UTMC Errata Sheet

UT69151 SμMMIT RTE Register Compliance

UTMC has identified the following deviation from intended functional performance for prototype and reduced high reliability versions of the UT69151 SμMMIT RTE (device code MM022A).

Figure 1. Corrupted Write Cycles

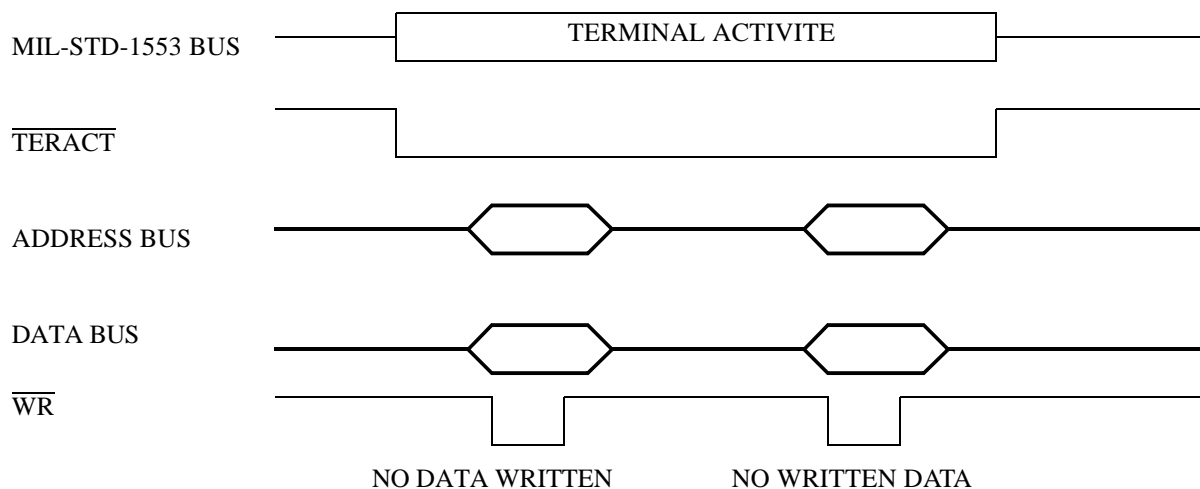
If the host processor attempts either a memory or registers cycle while $\overline{\text{TERACT}}$ is low, the host cycle is corrupted. The SμMMIT RTE indicates that MIL-STD-1553 message processing has started by asserting $\overline{\text{TERACT}}$ (i.e., active low). $\overline{\text{TERACT}}$ remains low until MIL-STD-1553 message processing completes. For write cycles, no data is written into either the protocol handlers register or into the cycle specific address location. For read cycles, invalid data is presented to the host on the SμMMIT RTE's external data bus. The anomaly occurs in all modes of operation bus controller, remote terminal and monitor. Additionally, the anomaly is independent of device is configuration, i.e., multiplexed, non-multiplexed, 8-bit mode, 16-bit mode.

The production revision of the UT69151 SμMMIT RTE (MM019B) will incorporate a circuit change to the MMU eliminating register and memory bus corruption during memory/register accesses occurring concurrently with MIL-STD-1553 message processing. Production versions of the UT69151 SμMMIT RTE, with the design fix, are scheduled for end 4Q98 deliveries. A system work-around is to eliminate memory or register accesses while the SμMMIT RTE is processing MIL-STD-1553 messages.
